Meeting Date: May 5, 2022
Petitioner: Banning and Platinum Properties
Subdivision: **Colonnade Section 3B**
Location: CR 750 N south of town center

McCordsville Technical Committee
McCordsville Town Engineer

The Planning and Building Dept. has reviewed the Primary Plat and submitted for Rivendell and has the following comments that need to be resolved:

Re: Rivendell Primary Plat

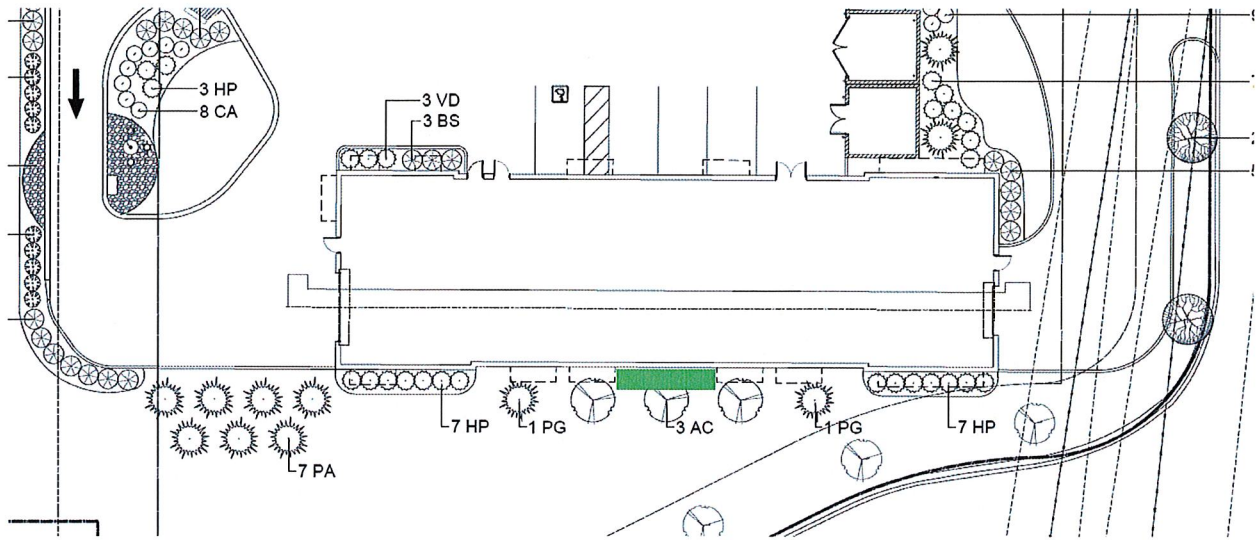
2. We are concerned the 32-vehicle queue is not enough to keep vehicles off the Meijer ring road on your busiest days. Please provide a plan sheet showing 4-wide stacking back to the lot's entrance. We anticipate additional curb adjustments may need to be made, as well as pulling back the island separating the stacking lanes from the vacuum stalls.

3. We'd like to see the island between the stacking lanes and vacuum stalls widened. A 3' wide island is very narrow and will be difficult to properly maintain. Additionally, we'd like to see it incorporate both shrub plantings and grass, not just mulch as ground cover. The lane between the two sets of vacuum stalls is currently shown at 35.8'. We'd like to see this lane narrowed to 30' with the 5.8' added to the island width.

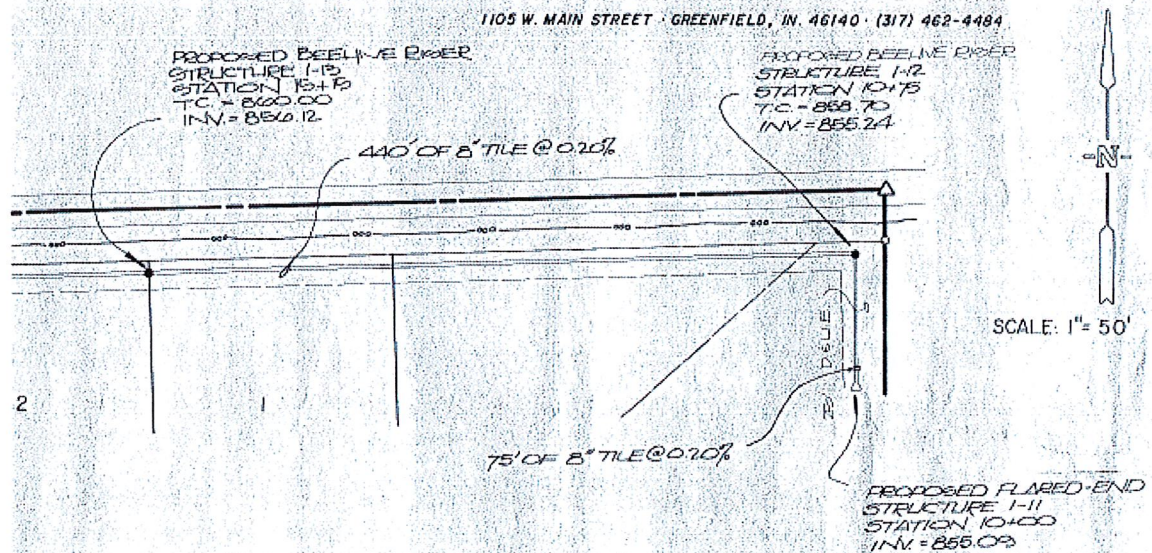
1. A sanitary sewer agreement is needed prior to recording of the plat.
2. On C120, the intersection by lot 309, please make that a 3-way stop.
3. On C120, I am concerned about the proposed intersection by lot 401. Should this be a curve and no stop signs? There are no conflicts at this intersection.
4. Is a ditch crossing necessary for earthwork? Does both north and south sides balance?
5. On the passing blister, does property have to be acquired? On C210, the passing blister does not show a replacement for the existing roadside swale. Also the row of evergreen trees is not show. Are they impacted? There is an existing 8" tile that runs east parallel to 700N to the ditch. Is the tile impacted?

6. General SSD comment, the SSD should run under the centerline of the swale. Is there a cover issue, or is this for drawing clarity? How will the contractor know?
7. On C150, the SSD behind lots 326-329 should be positioned under the swale. There might also be a conflict with the parallel storm line if the SSD is not positioned to the west of the RCP.

8. On C150, the proposed riser by lot 331 is adjacent to a storm structure. Could the SSD be tied in to eliminate the need for the riser?
9. On C152, the SSD by lot 413 has a lateral and the mainline both cross an RCP. The SSD for lot 352 could come out of the adjacent storm structure. The mainline could be shortened to tie into the structure by 413 so it doesn't have to cross. I am worried about conflicts and cover on the SSD.
